STEWART BUILDERS LLC

Permit No: PRRES20212466

Project Address: 508 SE DAVID RD, LEES SUMMIT, MO 64082

BY _____ STRUCTURAL REVIEW
HD ENGINEERING & DESIGN
DATE _____ HD: 41202 DATE: 5/20/2021

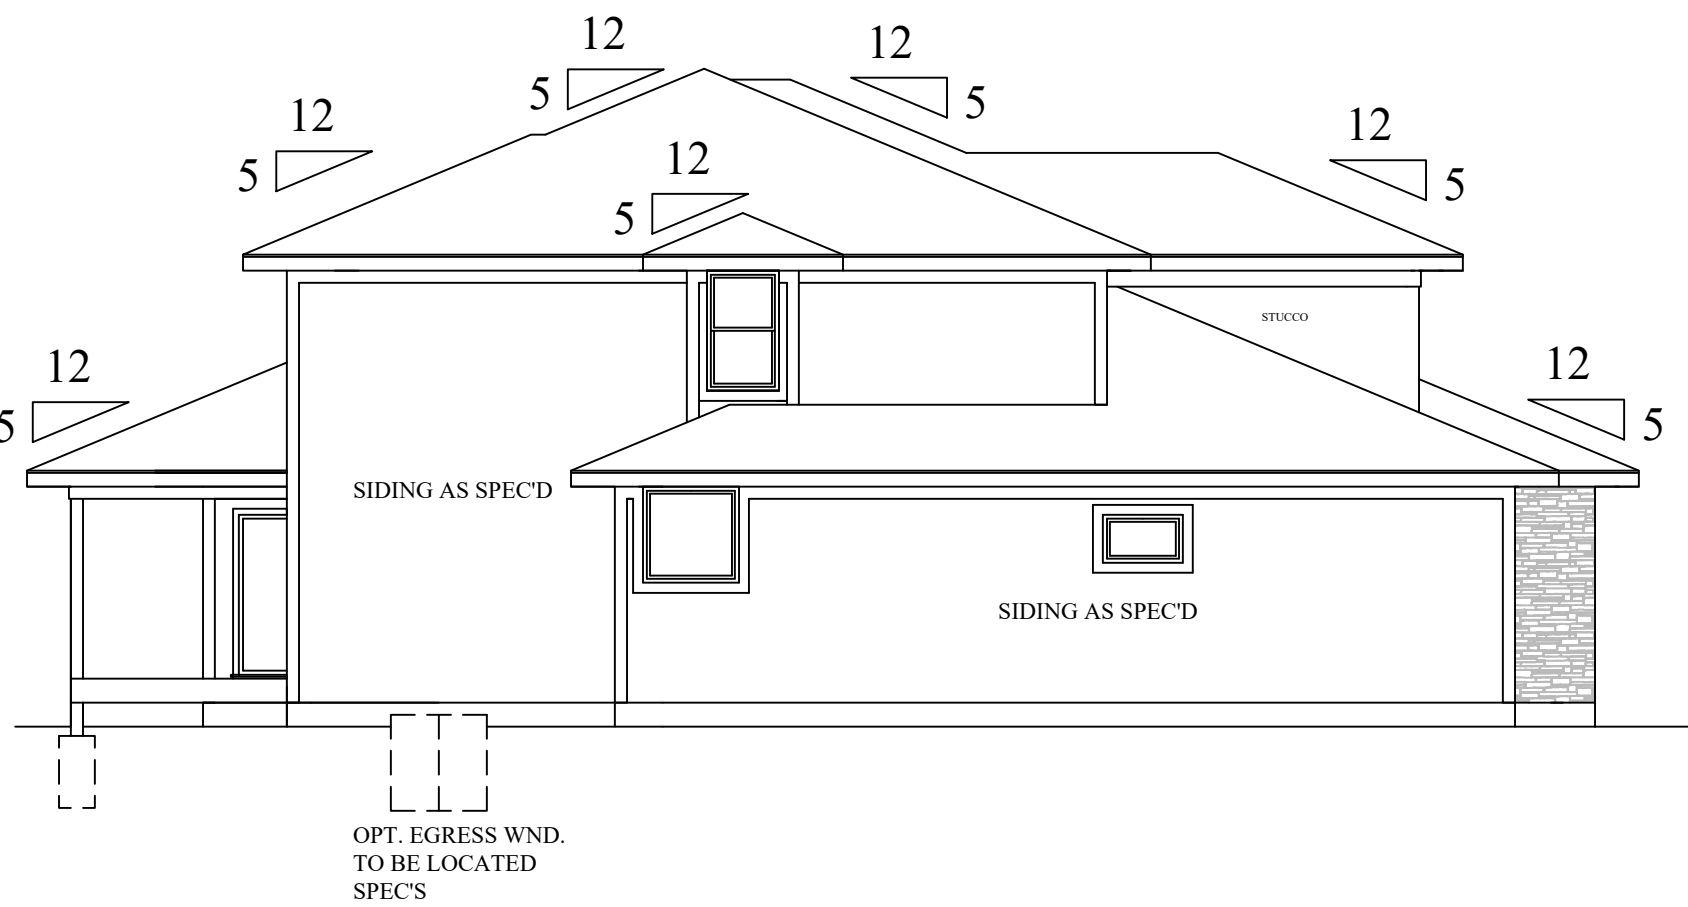
4. Identify type of joist package or floor truss package (if used) complete with layouts, fastening details, blocking and bracing requirements and minimum sheathing. deferred

I JOISTS TO BE USED DEFERRED SUBMITTAL

'NON WALK-OUT ELEVATIONS'
FRONT ELEVATION - B
1/4" = 1'-0"

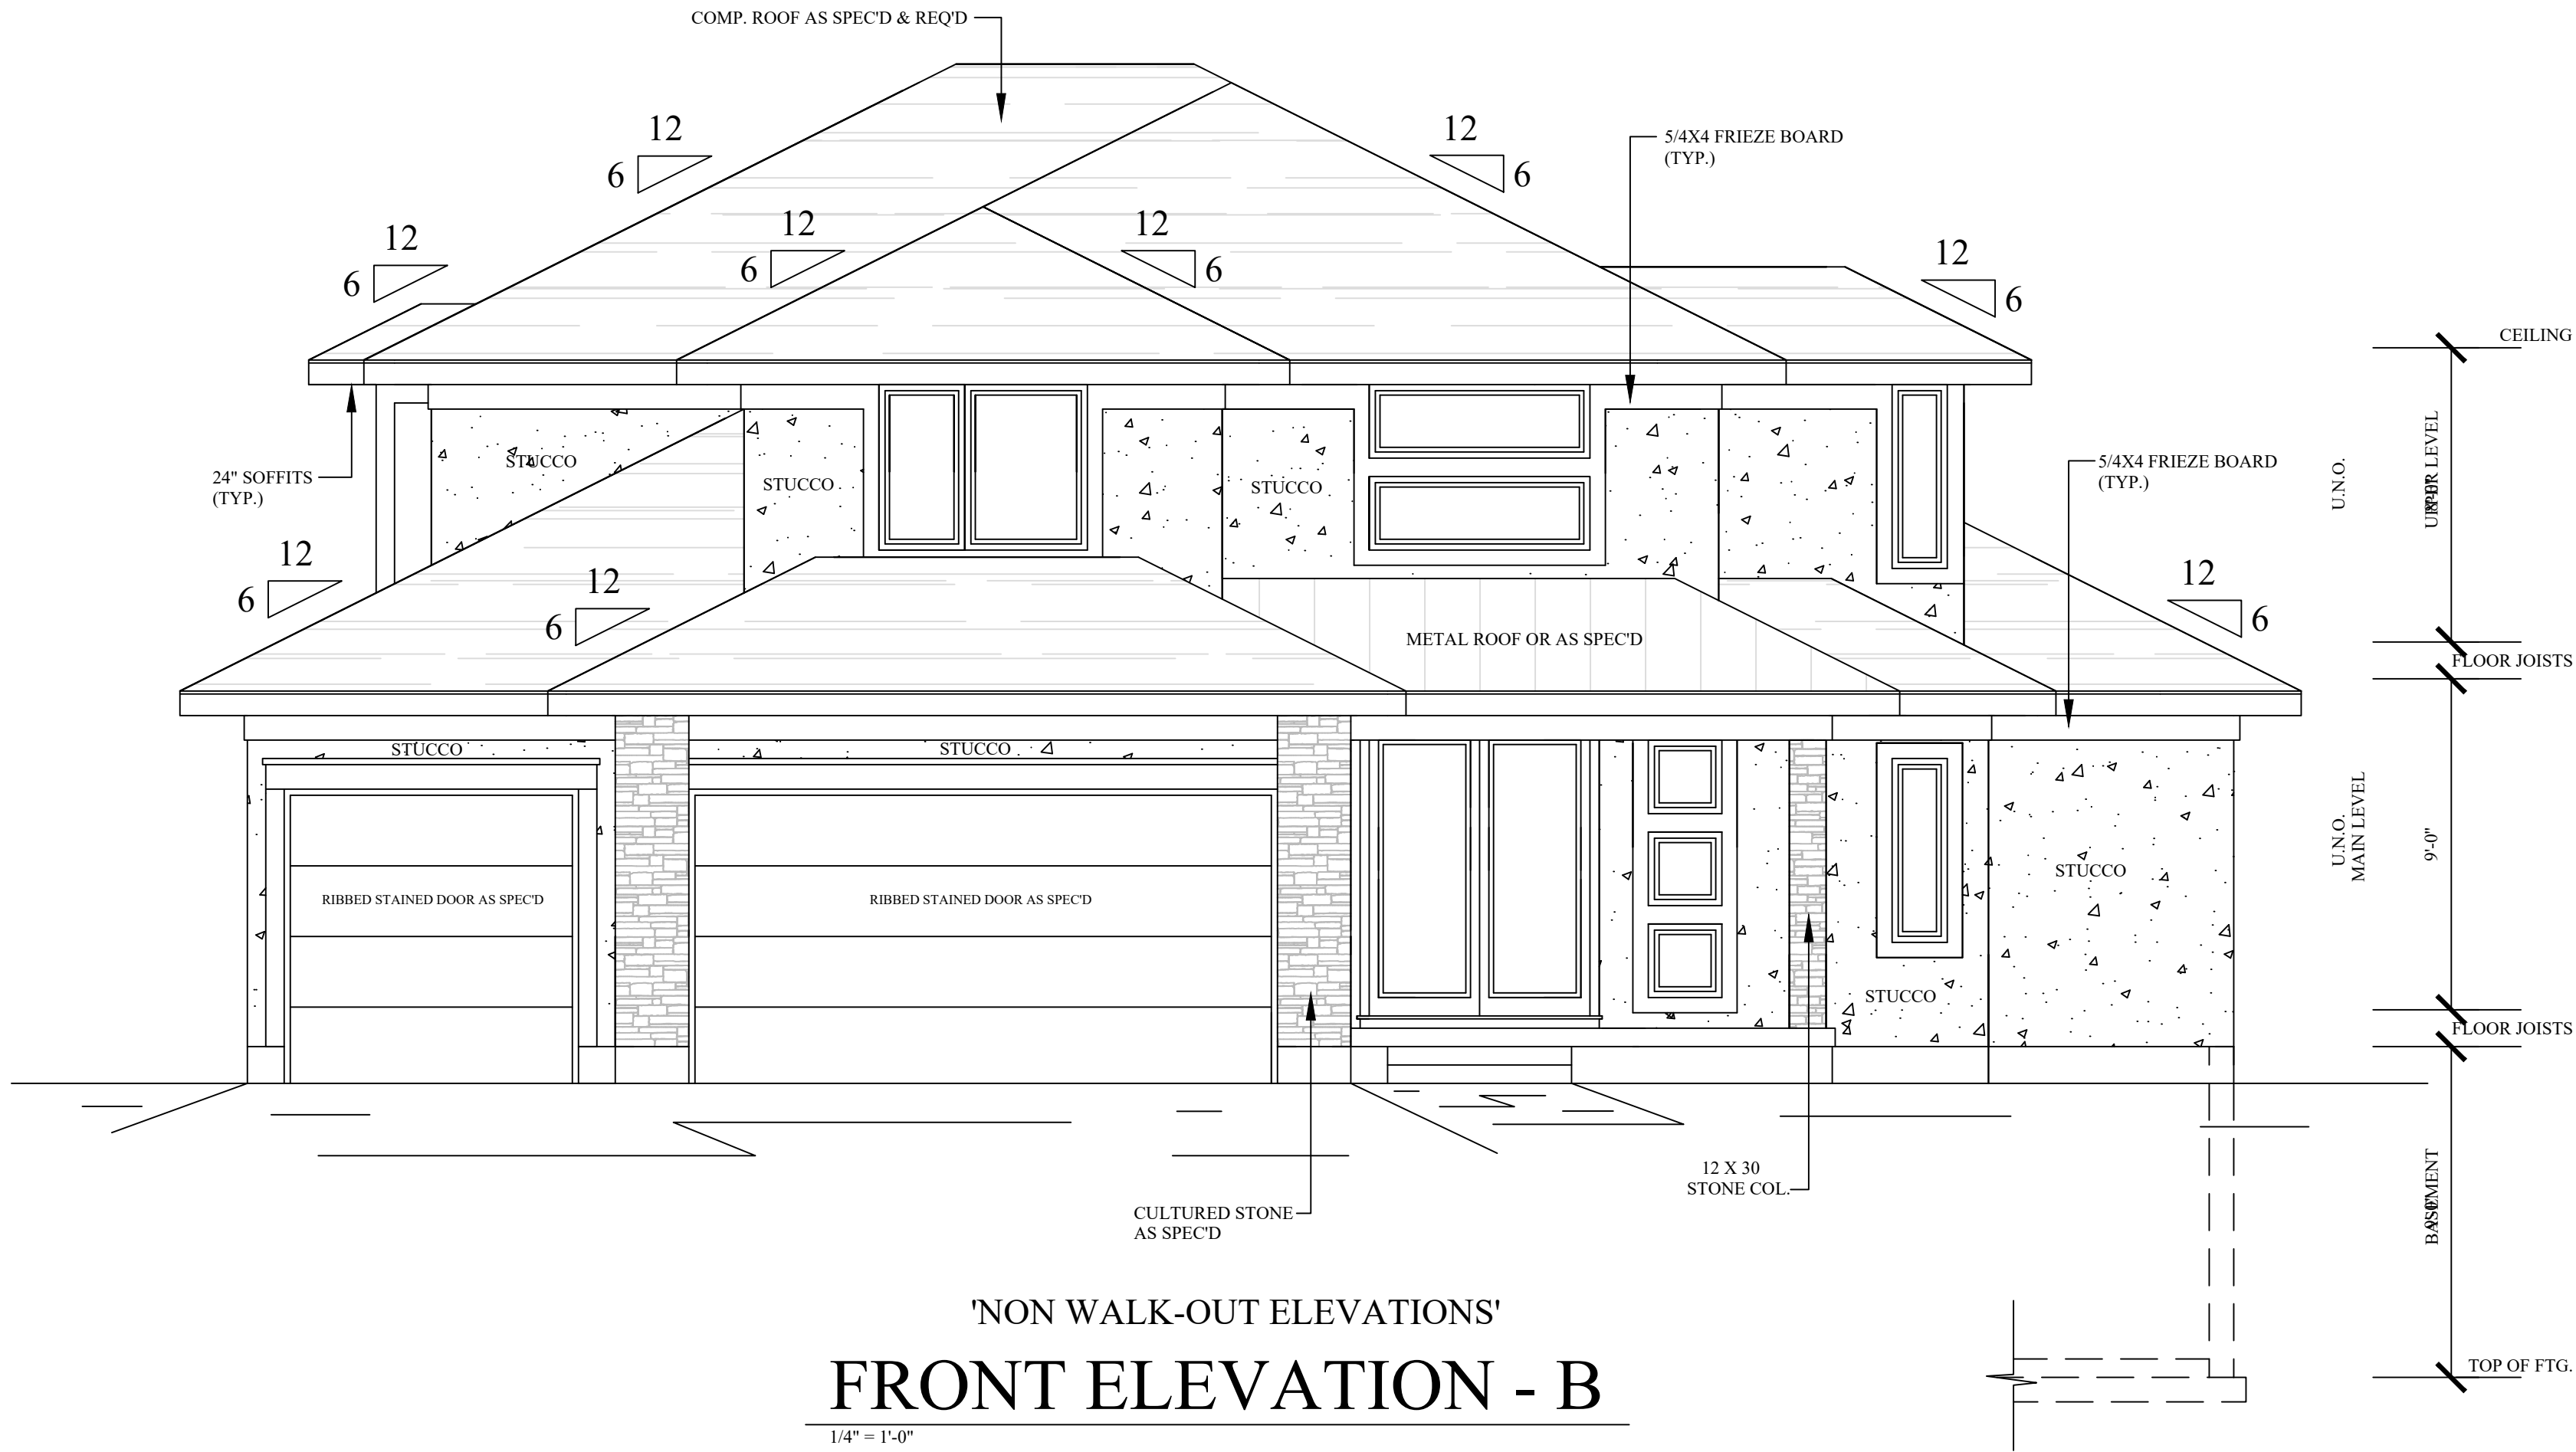
5. need to have standard basement elevations, currently have walkout elevations (first page)

SEE REVISED CLOUDED SHEET 1 AND 3.

'FULL BASEMENT OPTION'
BASEMENT PLAN - B - FULL

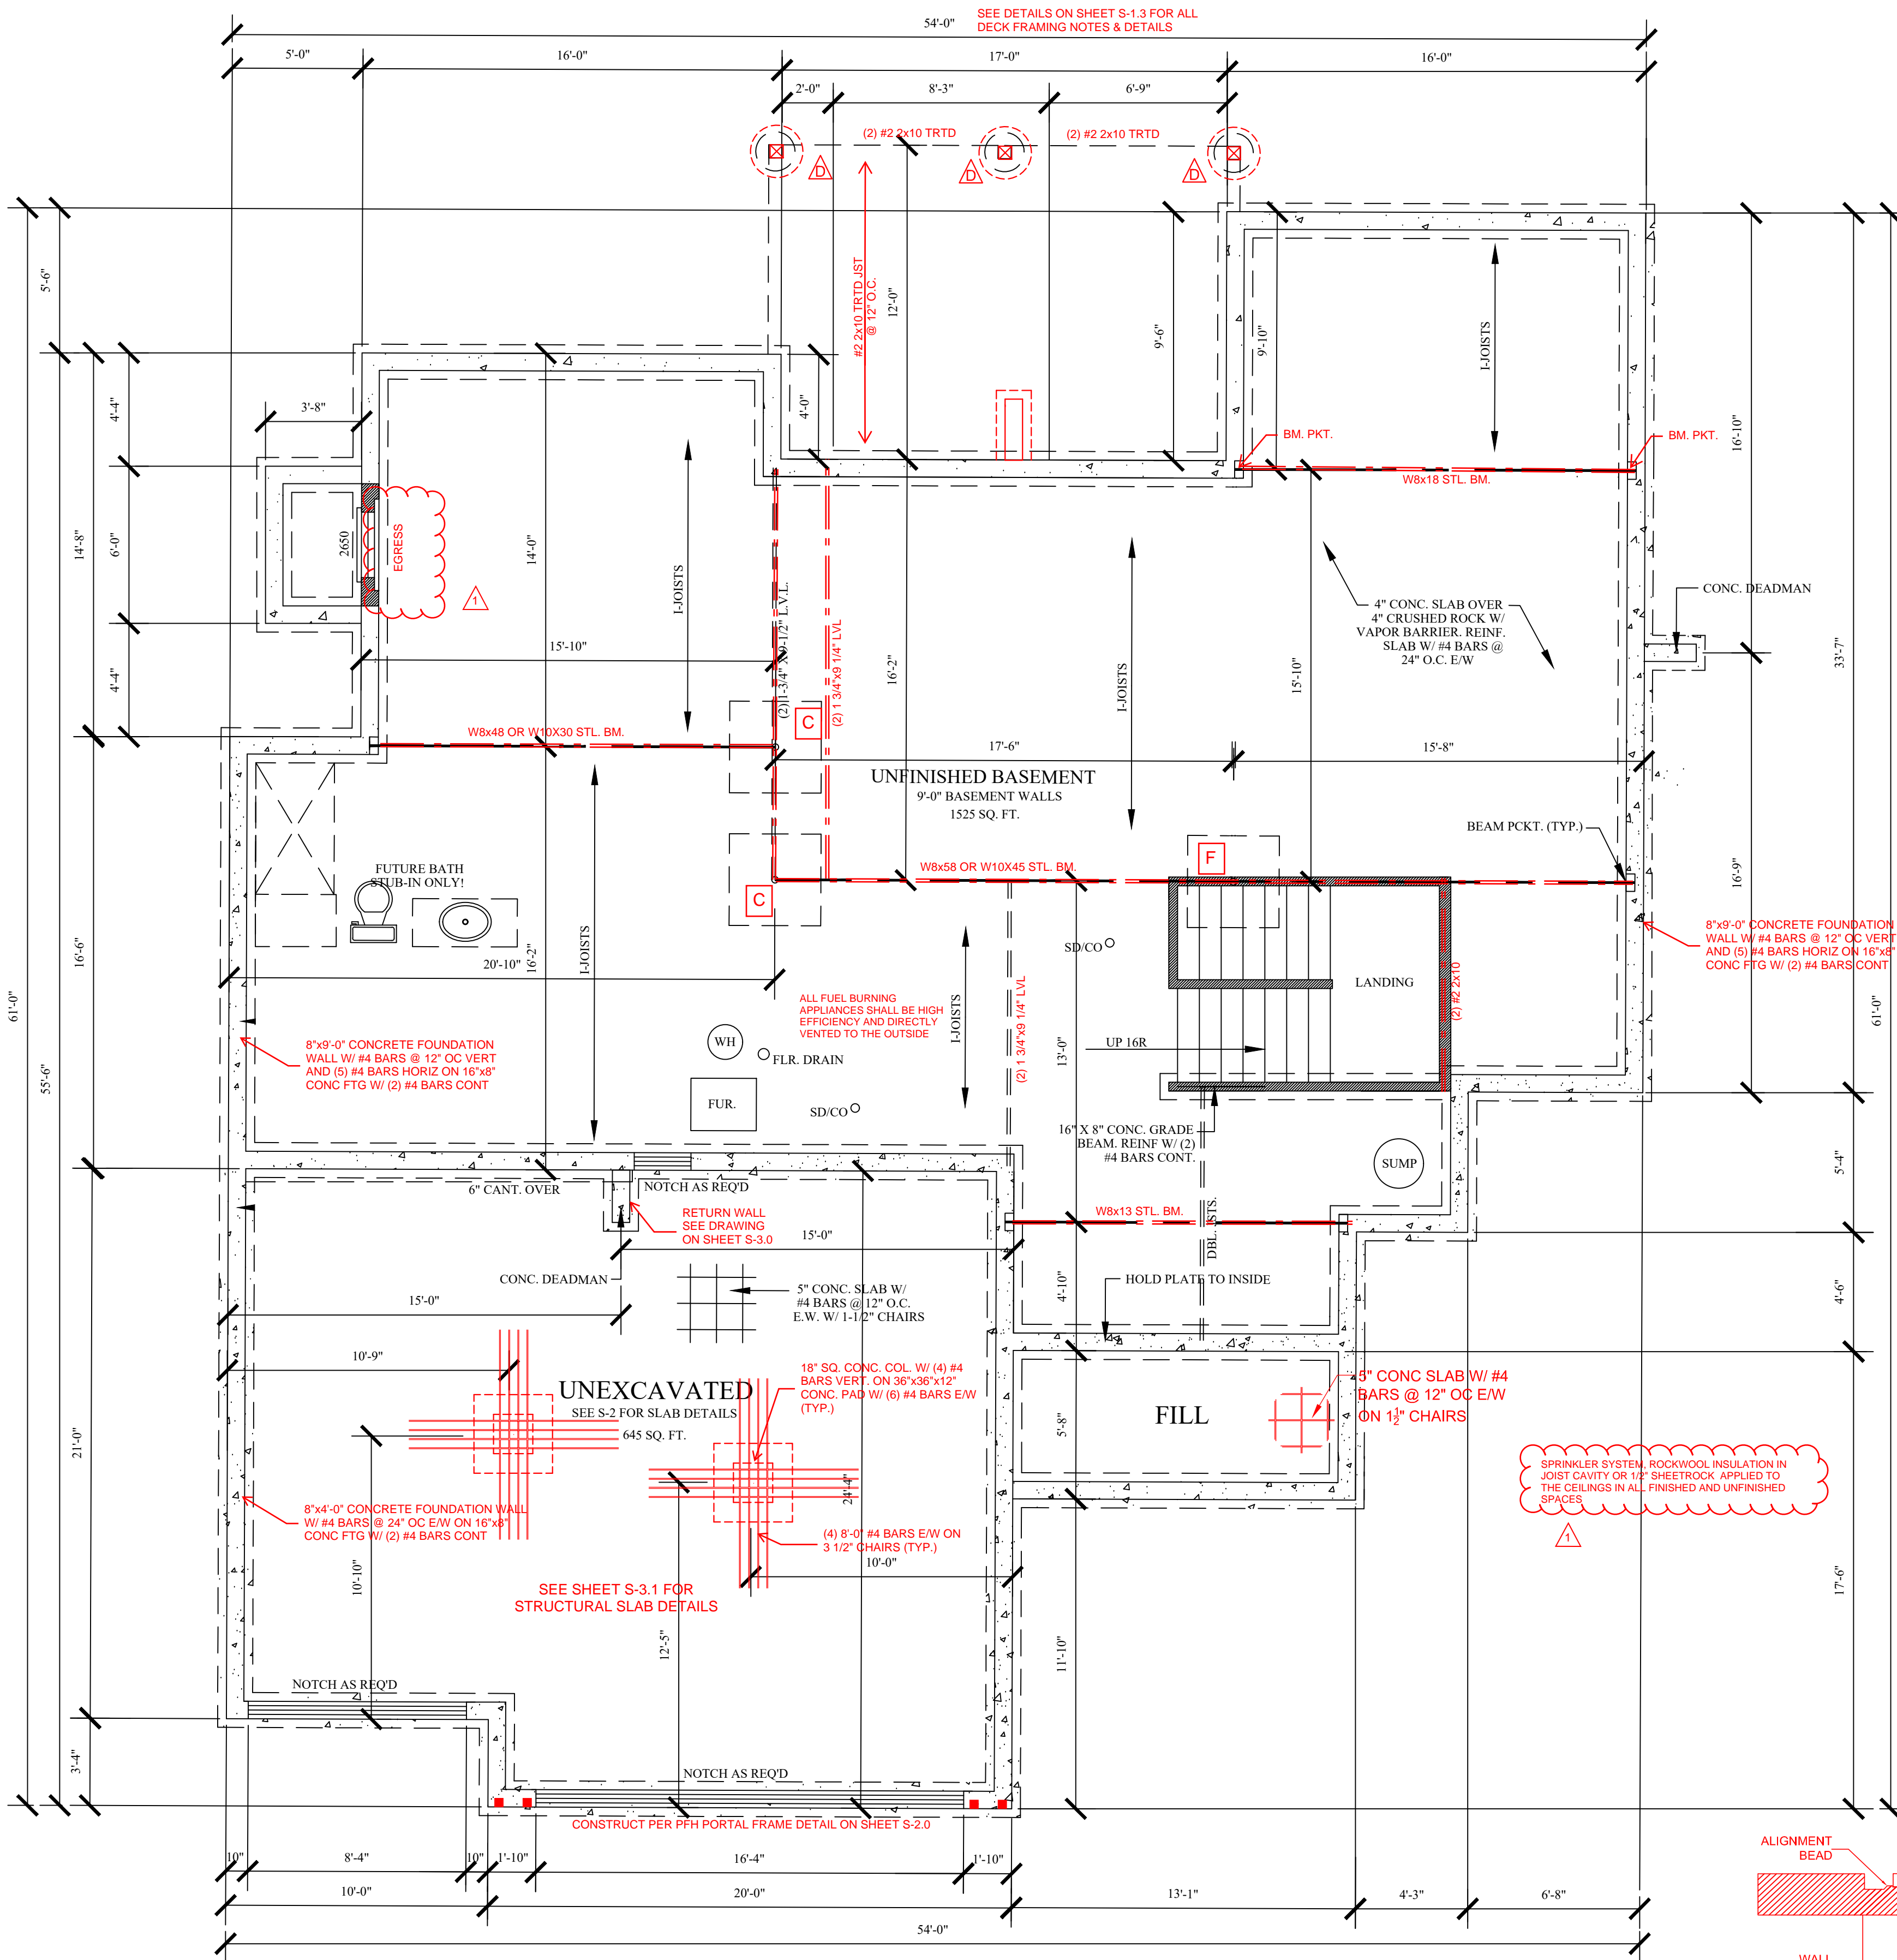
3. Identify type of protection used in unfinished areas under floor trusses. (IRC Section R501.3)

SEE CLOUDED REVISED SHEET 3.
